URGENT MEDICAL DEVICE RECALL (CORRECTION)

HeartMate II® and HeartMate 3™ System Controllers
Used with HeartMate 3™ LVAS and HeartMate II® LVAS
(Model Numbers: 106017, 106762, 107801, 106531US,
106531INT, 106531LF2)

October 2025

Figure 2: Backup Battery Fault Alarm, HeartMate 3™ LVAS Clinician Instructions for Use

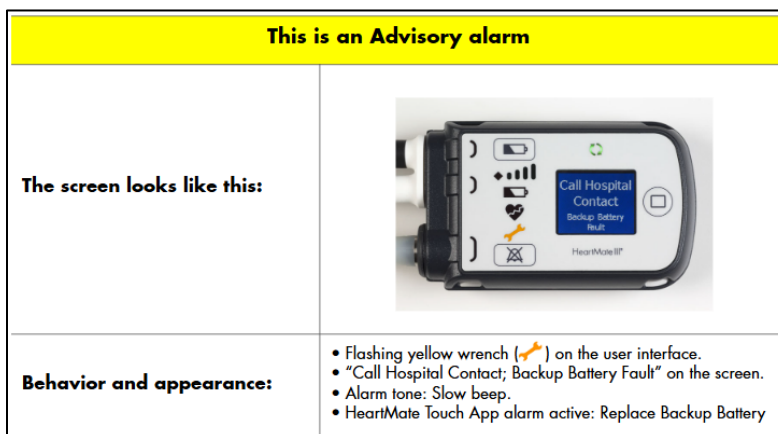
When the Backup Battery Fault Alarm is active, this Advisory alarm will appear as a flashing yellow wrench on the user interface and “Call Hospital Contact; Backup Battery Fault” will appear on the screen (see Figure 2 below), accompanied by a slow beep tone. When in a clinical setting, the HeartMate Touch App will have an active alarm that reads “Replace Backup Battery.”

As a reminder, when this alarm is active and the pump is running and flow is maintained (indicated by the green arrow symbol ) , this alarm does not affect the controller or pump functionality.

If further assistance is needed regarding the Backup Battery Alarm after following Instructions for Use, contact your Abbott representative for troubleshooting steps to determine if a battery or system controller replacement is required for resolution.

This guidance is also provided in the existing Clinician Instructions for Use. The HeartMate II® and HeartMate 3™ Left Ventricular Assist System (LVAS) Clinical Instructions for Use outlines that if the Backup Battery Fault Alarm is active, patients should first ensure that they remain on external power

sources (e.g. 14V batteries or AC power via the Mobile Power Unit) until the issue is resolved. During this time, the pump is operating as intended and providing flow. To resolve the issue:

- Patients must call their hospital contact immediately for diagnosis and instructions.
- If a System Controller exchange is needed, remind the patient that a caregiver must be present during the exchange and that all labeling instructions on System Controller exchange must be followed.
- If a backup battery replacement is needed, advise the patient to visit your clinic and have a clinician replace the System Controller 11 Volt Lithium-Ion backup battery.
